ORIGINATION FORM

Proposed Revisions to a Standard Plans Index

Index Number: 700-031

Index Title: External Lighting for Signs

LUMINAIRE SUPPORT STRUCTURE

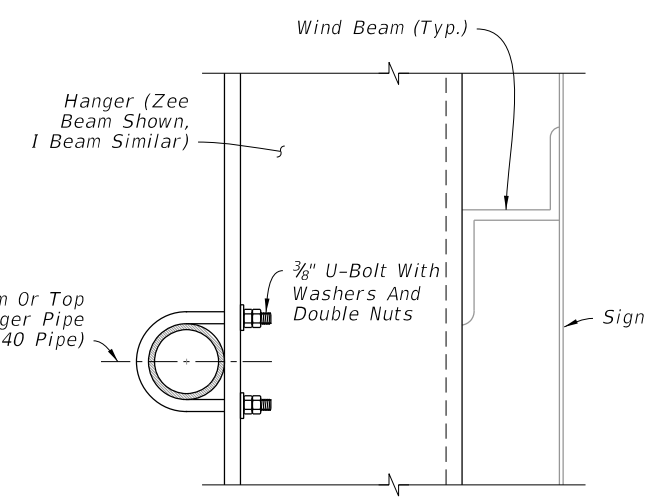
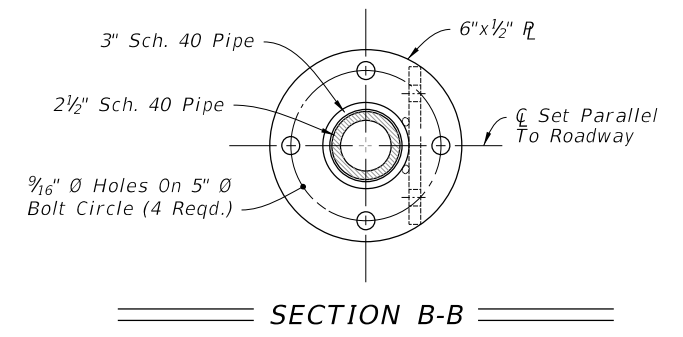
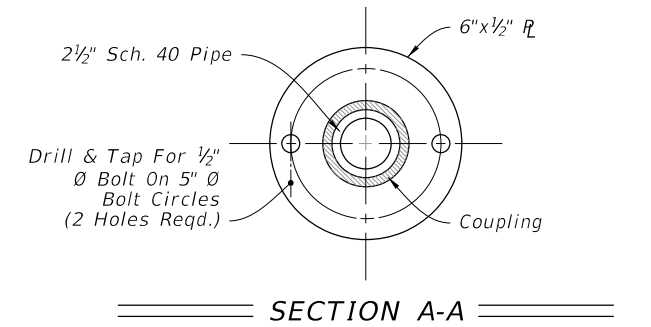
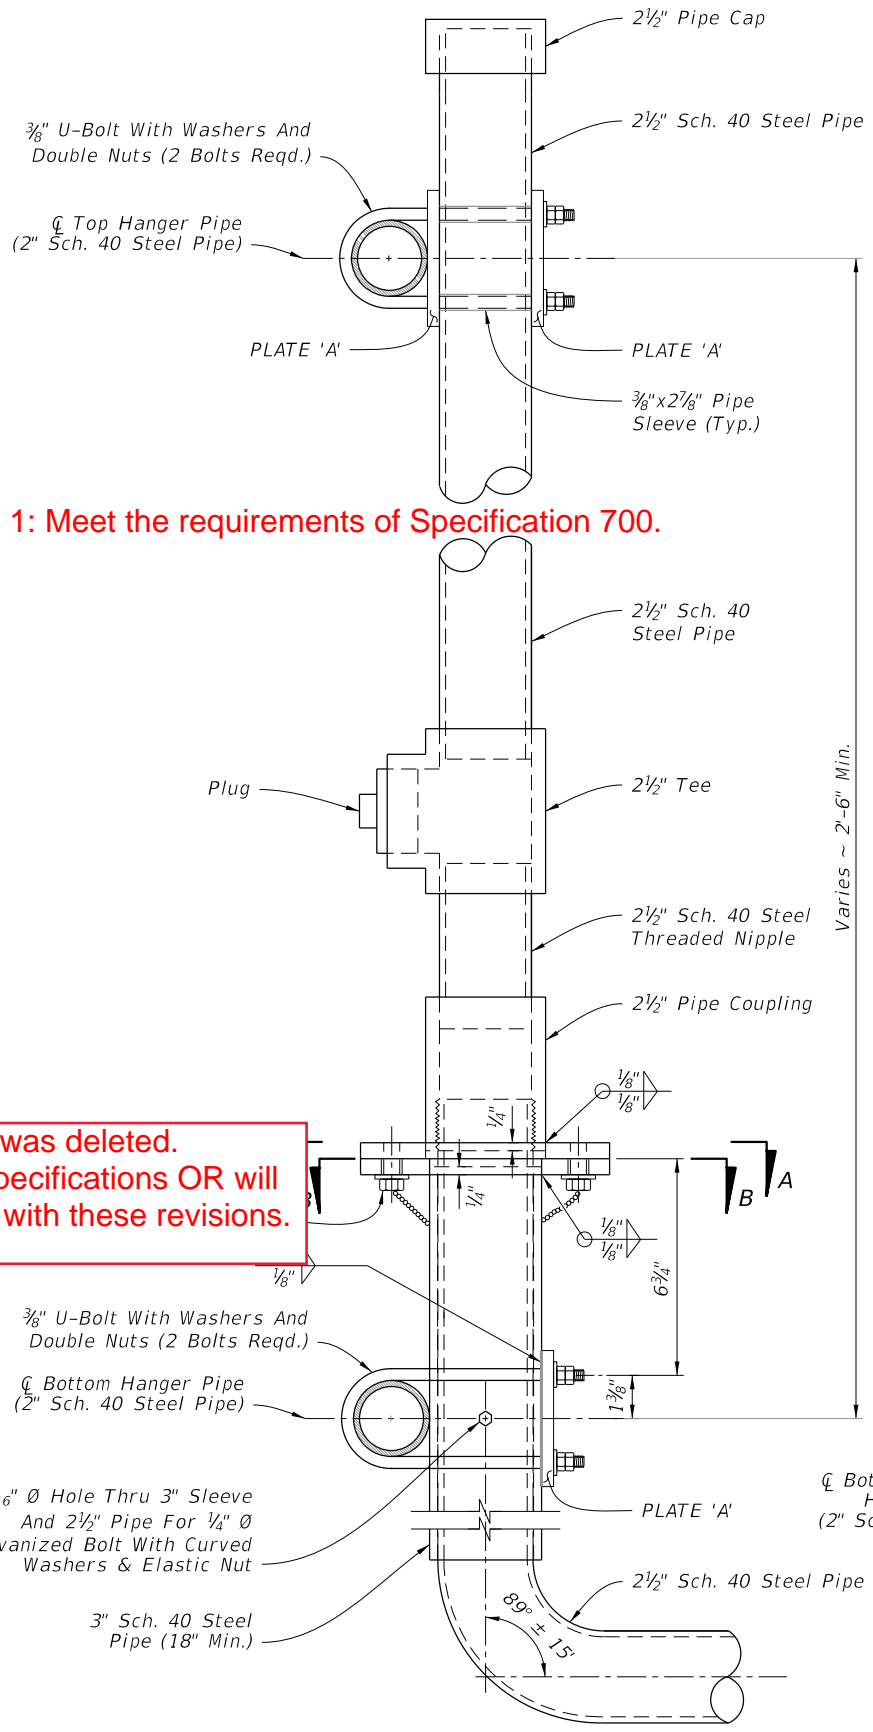
- ADDED NEW NOTE 1: Meet the requirements of Specification 700.**
- 1. NOTES**
1. Install hanger pipe to each vertical beam crossed with a 3/8" U-Bolt, lock washers and hex nuts. Cap both ends of the horizontal pipe.
 2. Materials;
 A. Steel Pipe: ASTM A53 (Grade A or B)
 B. Steel Plate: ASTM A36
 C. Bolts: ASTM A307
 D. Hex Nuts: ASTM A563
 E. Washers: ASTM F436
 3. Coating: Hot-Dip Galvanize pipes, plates, structural shapes: ASTM A123. Fasteners and hardware: ASTM A153.
 3. All pipe dimensions are NPS.
 4. Chord O.D. + 5" (Min.)

GENERAL COMMENT: Some material information was deleted. Information is either already covered in Standard Specifications OR will be added to Section 700, 962 or 965 in conjunction with these revisions.

LAST REVISION 11/01/22	DESCRIPTION:		FY 2023-24 STANDARD PLANS	EXTERNAL LIGHTING FOR SIGNS	INDEX	SHEET
			700-031		2 of 2

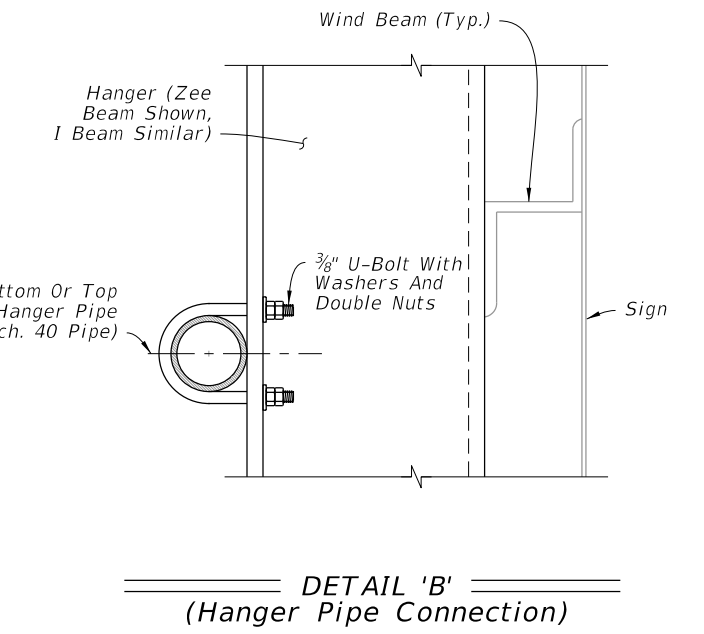
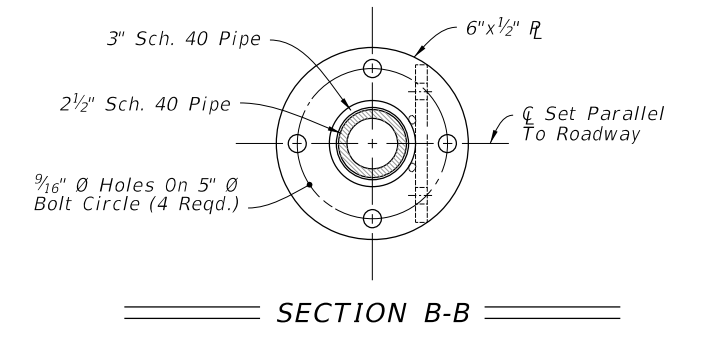
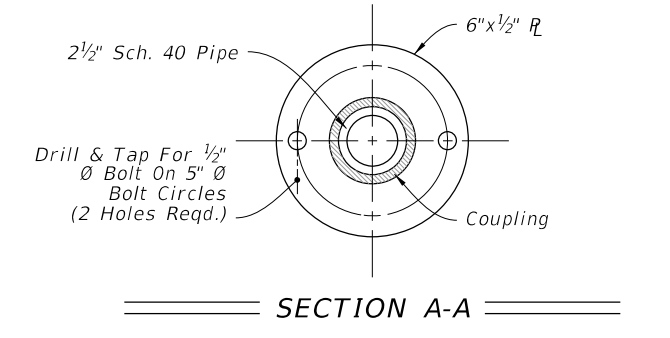
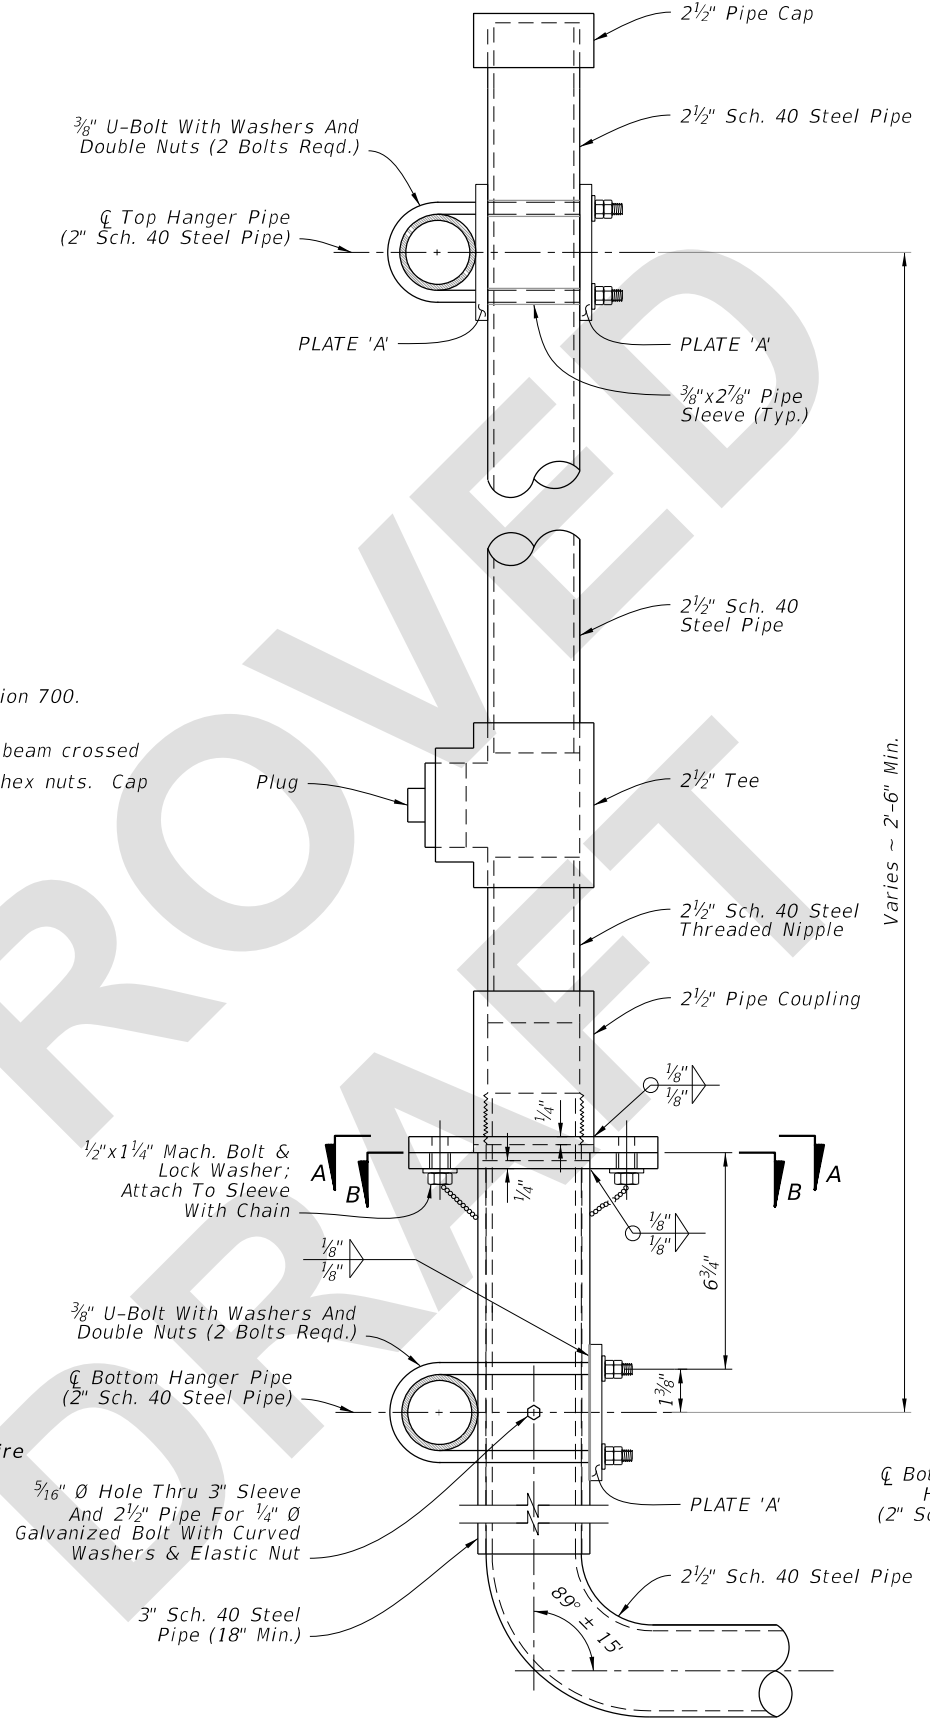
Added Note 1 - "Meet the requirements of Specification 700"; Deleted Note 2 and 3; Renumbered Notes.

- NOTES:**
1. Meet the requirements of Specification 700.
 2. Install hanger pipe to each vertical beam crossed with a 3/8" U-Bolt, lock washers and hex nuts. Cap both ends of the horizontal pipe.
 3. All pipe dimensions are NPS.
 4. $\frac{\text{Chord O.D.} + 5"}{2}$ (Min.)
